Title: Heater Upgrade II.1		
AG-SB-2023-05-B-EN	Effective Date: 01.12.2023	Compliance Category: A - MANDATORY B - RECOMMENDED C - OPTIONAL
Applicability		
Aircraft type & model: Cavalon	Affected Serial number(s): built after 05/2022 and before 10/2023	
The maintenance manual to be referenced is this stated or subsequent issue.		As per AutoGyro website
This form is the response from AutoGyro GmbH either against a problem found in the product in service requiring a containment or rectification action, or as service information for aircraft modification incorporation. For help, contact airworthiness@auto-gyro.com .

Reason and overview of the Service Bulletin (cause of problem if known)

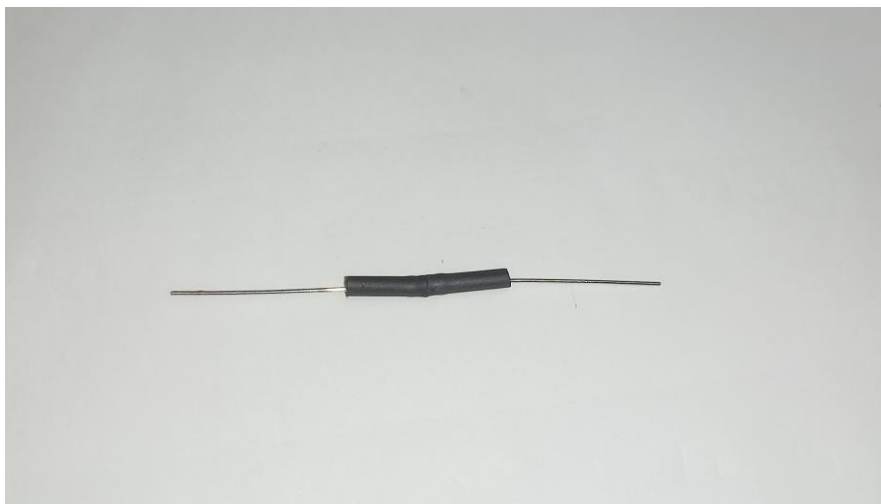
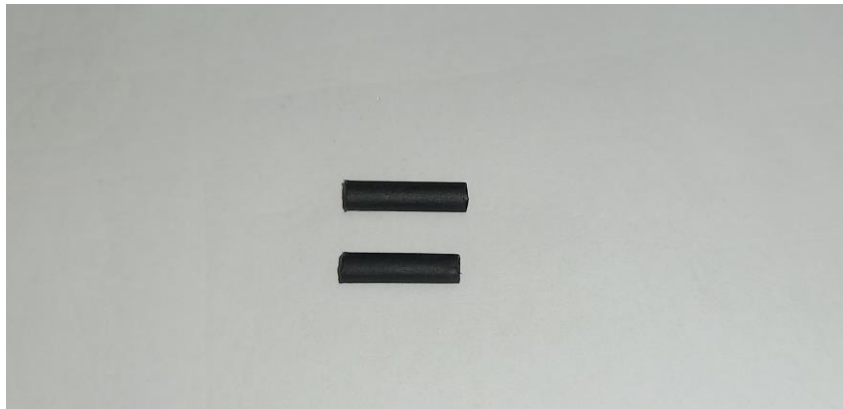
- 1.) Remove the cap of the rotary control by pulling it off.

2.) Loose the nut and remove the potentiometer to the backside of the panel.

3.) Cut two pieces of shrink sleeve to 10mm and put in on both sides of the electrical resistor.

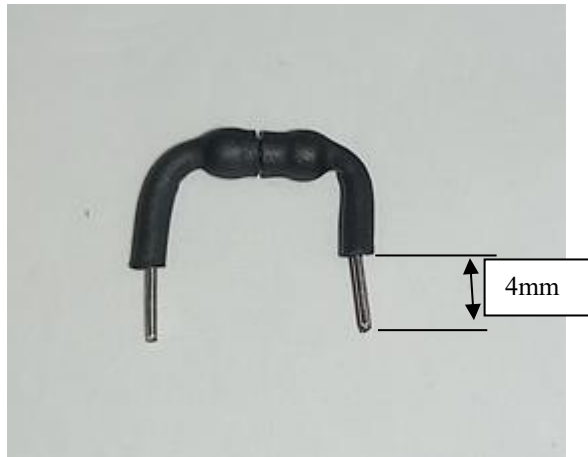
- 4.) Shrink the sleeve and cut both ends of the resistance to approximately 4mm.

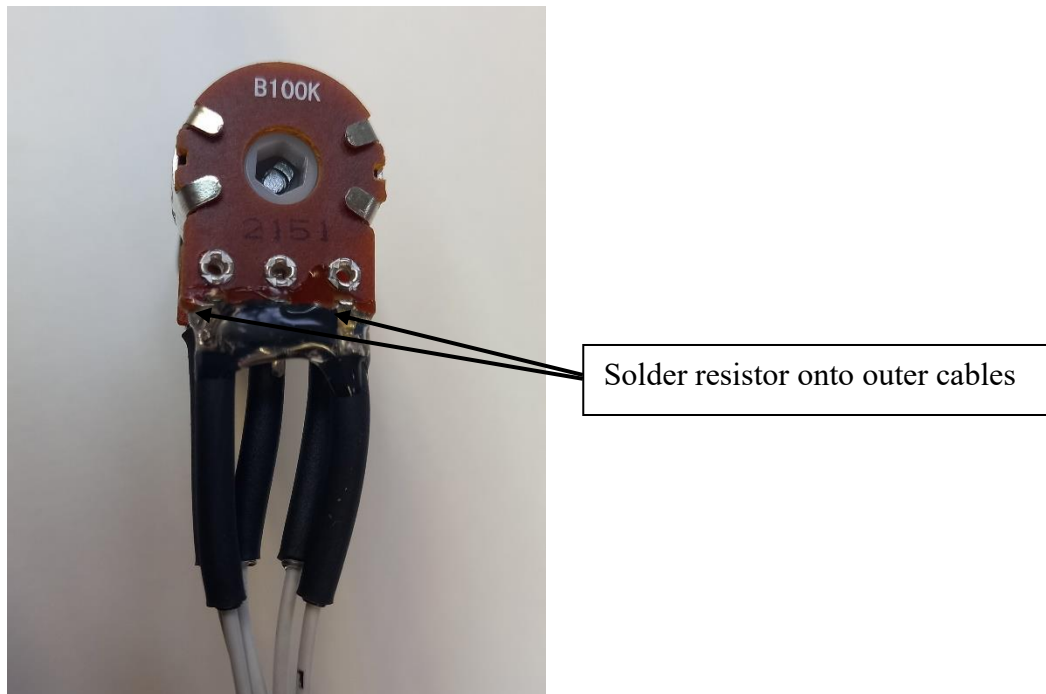
- 5.) Install the resistance onto the potentiometer (be careful to cover the potentiometer against Solder) – check afterwards for secure connection.

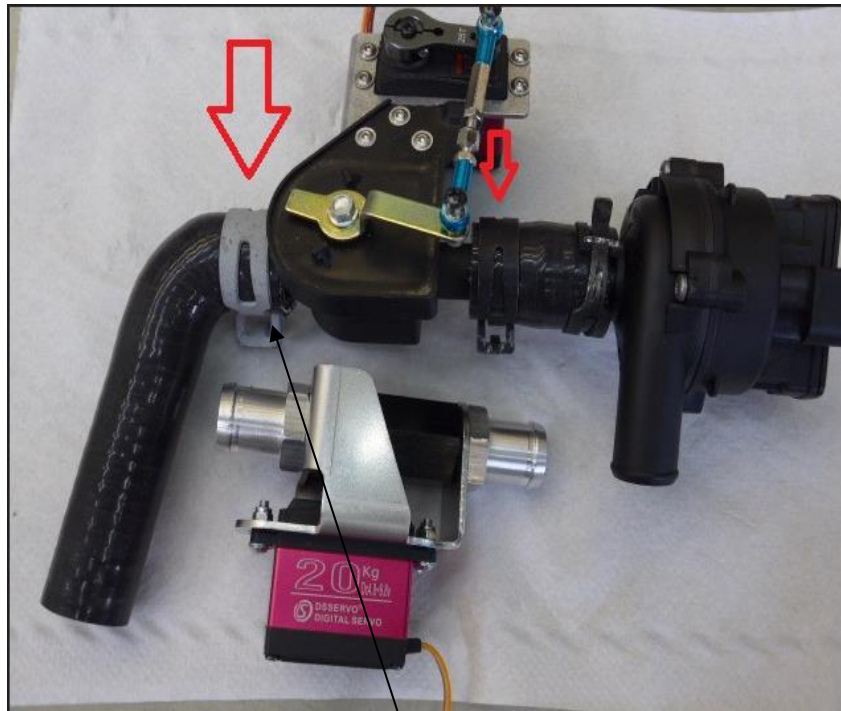
- 6.) Secure solder joints with hot glue (such as hot melt adhesive 202 from Würth), be sure that the shaft of the potentiometer is not getting in contact with hot glue.
- 7.) Re-install potentiometer, tighten the nut and put on the cap

Clamp removed, hose removed from old valve unit, here to see on the left side, same on the other side with the clamp

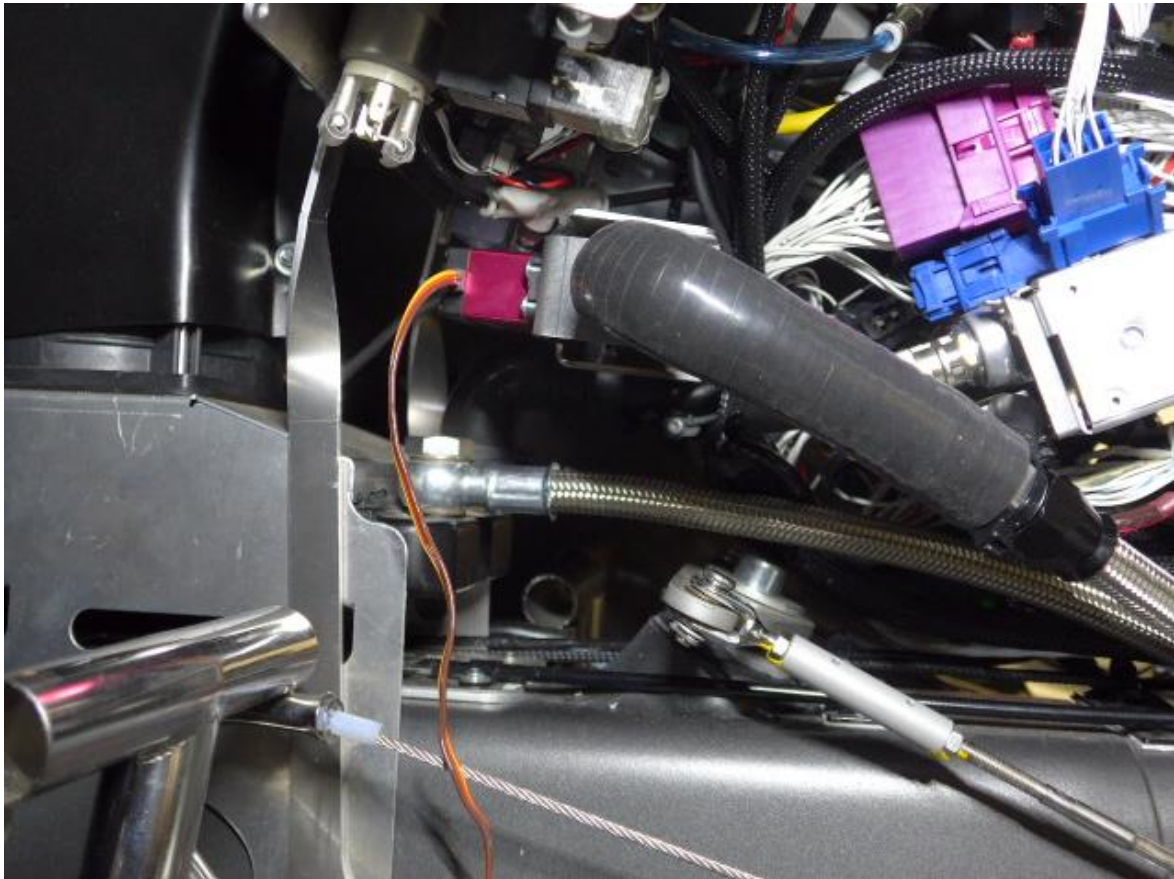
- 3) Remove the carpet in the foot well, cover the parts there with rags to absorb the coolant and protect them.
- 4) Remove the hose clamps from the valve unit and the plug where the servo is attached.
